Tusuka Jeans Ltd. (Unit-2)

18th January 2017

Observation

Typical beam Column Layout (Ground floor)

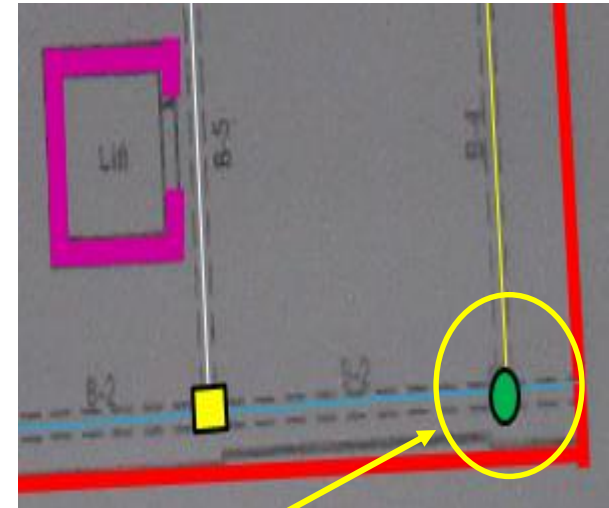
Highlighted column was shown as C-5 (500mmX500mm) at all level in column schedule. However, at Ground floor this column was found as circular column of 700mm diameter. Factory engineer to update as-built drawing reflecting the as constructed condition.

Typical beam Column Layout (1st to 8th floor)

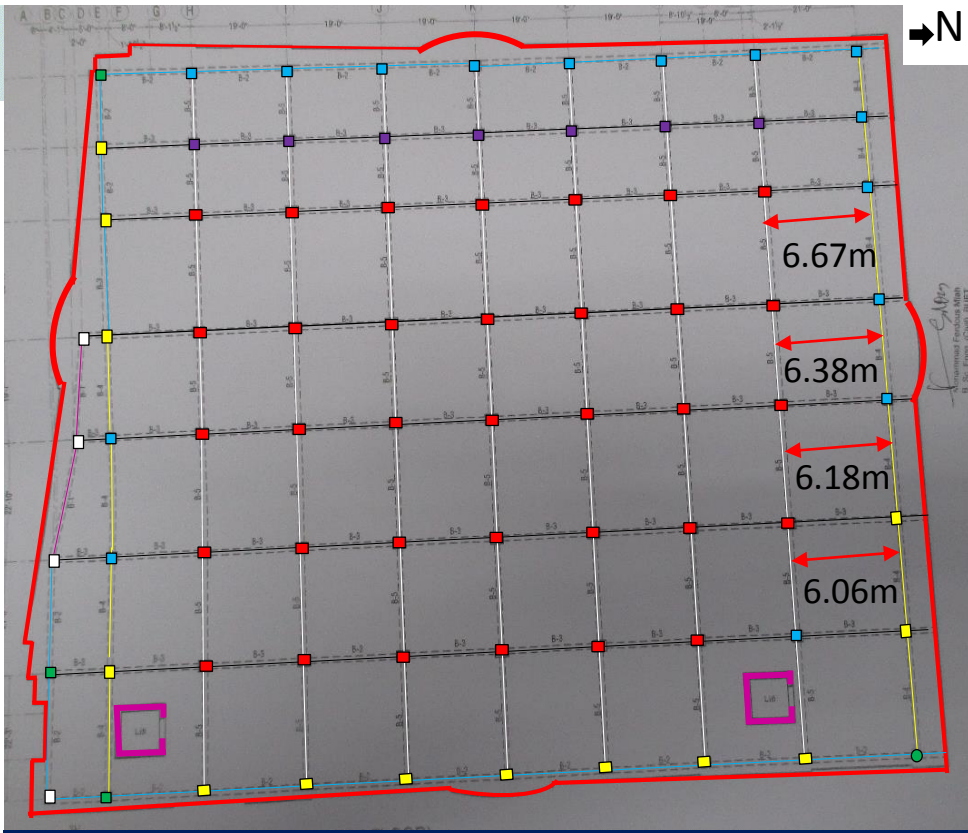
Grid dimension varies at north most bay. The dimension didn't match with the provided drawing. The length of the grid decreases from west to east direction.

Washing area of Ground floor

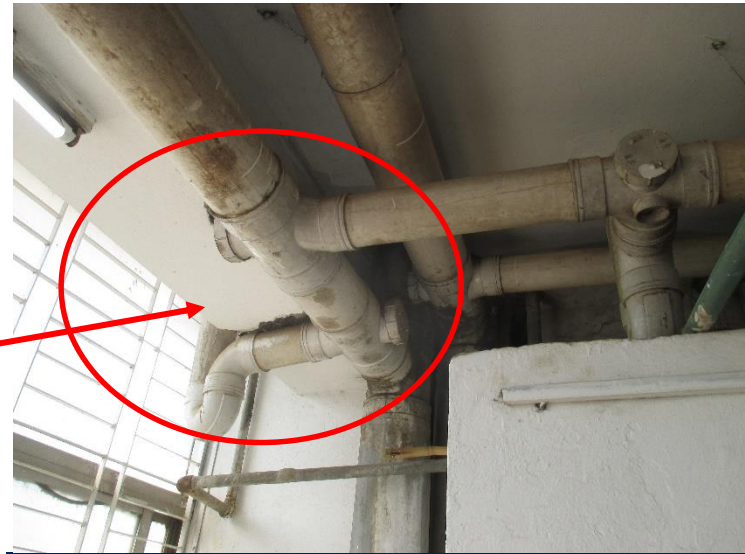
Water ingress at basement through Ground floor slab under washing area of Ground floor. Factory engineer to investigate the cause of water ingress and repair accordingly.
